IMPERIAL ROAD DESIGN MANUAL
REVISIONS July, 2011

FIGURE 4-1A ENTRANCE THROAT DETAIL

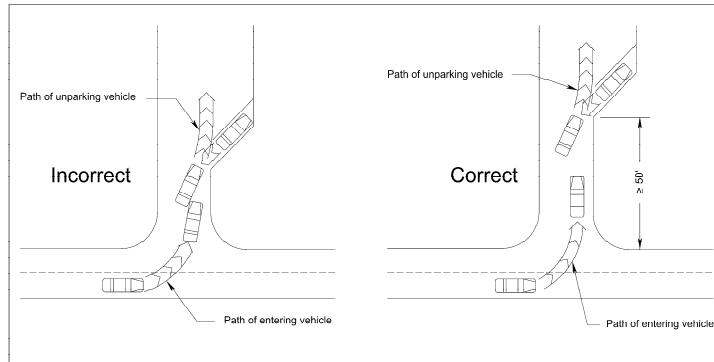
- Page F-85 – Added the following language under “TABLE 4-2”; *“Inadequate entrance length can also produce hazards to entering traffic on site. Particularly where the on-site parking can back out of and block the entrance and prevent a vehicle from entering. To avoid this problem, a distance of at least 50 feet should be used on entrance length where back out parking may interfere with entry movement.”*

Added the following Figure;
